This amendment is raised to answer Industry questions and to modify the draft RFP document, Statement of Requirements (SOR) and Attachment 4.1 – Mandatory Requirements.

## Appendix 2 Future Design Overview and Dataflow

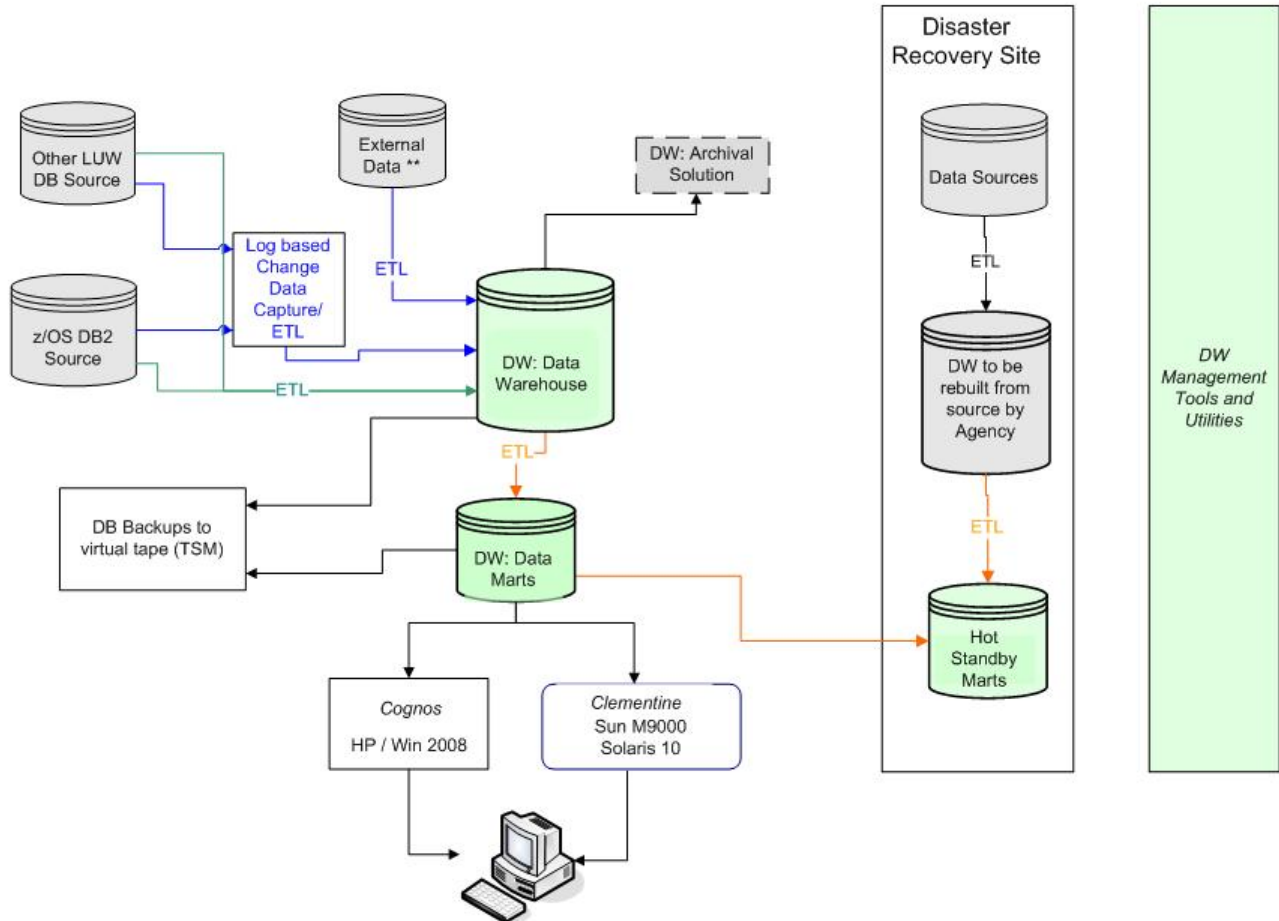
Appendix 2 (Page 30) Future Design Overview and Dataflow

In this diagram at top centre is a dashed box, shaded Green, titled DW: Archival Solution. The Green legend indicates it is in RFP scope, but there are no requirements detailed in the RFEP, or draft RFP for an Archival solution. Please clarify.

The diagram will be re-released with the Archival Item shaded grey to reflect that it is not in scope of the requirement. Please see Modification 021.

**On page 30 of 47 of the SOR, Appendix 2, Future Design Overview and Dataflow:**

**Delete in its entirety.**

**Insert: See revised Appendix 2 below.**
